FREDERICK COUNTY PLANNING COMMISSION January 9th, 2013

TITLE: Ramsburg- Sketch Plan

FILE NUMBER: S-933 AP# 13043

REQUEST: Sketch Plan

Exhibit #1: Ramsburg Sketch Plan

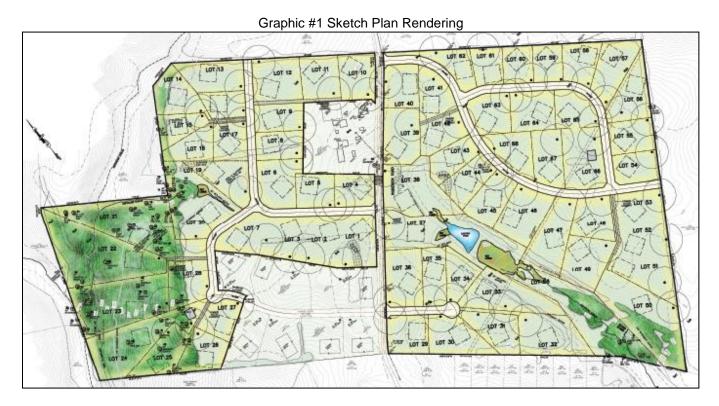
The site contains wet soils, which requires percolation testing during the restricted soils season (February 1- April 15). As shown on the sketch plan, 20 lots fall within the 1/3 restricted boundaries and 48 lots are non-restricted.

Parcel 1: The main access drive to serve this portion of the subdivision is proposed in between Lots 1 and 4 off of Roderick Road. This access drive travels north to dead end into the adjacent parcel, shown as Lot 34 of Urbana Overlook. The southern leg of the main access drive is designed to connect to the existing Layton Court which has access off of Roderick Road; all lots within parcel 1 are proposed to take access off of the proposed access drives. This roadway design and lot layout on Parcel 1 allows for through streets and multiple access points onto Roderick Road as well as a future connection to the adjacent parcel to the north. Lots 10, 11, 14, 15, 16, 22, 23, 25, and 26 within Parcel 1 are proposed to be panhandle lots.

Parcel 2: The main access drive to serve this portion of the subdivision is proposed north of Lot 40 off of Roderick Road. The main access drive travels south and east into a ring road with a spur that dead ends into an adjacent 209 acre parcel to the east. Both Lots 37 and 38 share a common drive that is located across from the main access for Parcel 1. There is a cul-de-sac that serves Lots 29-36 which is proposed to be opposite from the existing Layton Court access. Lots 32, 50, 51, and 52 within Parcel 2 are proposed to be panhandle lots.

All of the existing forested areas within the sensitive areas must be retained. The FSD demonstrates that no priority preservation areas will be impacted by percolation testing. The FRO plan has not been finalized or approved. The Sketch Plan illustrates that at least a portion of FRO mitigation requirement will be met by providing an easement along the stream system and waterbody buffer that is located on both parcels. FRO mitigation must be provided prior to lot recordation.

Should the FcPc give a favorable opinion of this Sketch Plan application (S-933, AP 13043) and allow the Applicant to proceed with percolation testing, Staff recommends that the following items be added as conditions to the approval:

- 1. The Applicant shall comply with all Staff and agency comments through the completion of the plan.
- 2. The approval of this plan is for percolation testing only and does not guarantee lot yield or approval of future preliminary plans or final plats. All future applications shall be reviewed and approved in the normal manner and in accordance with all applicable regulations.
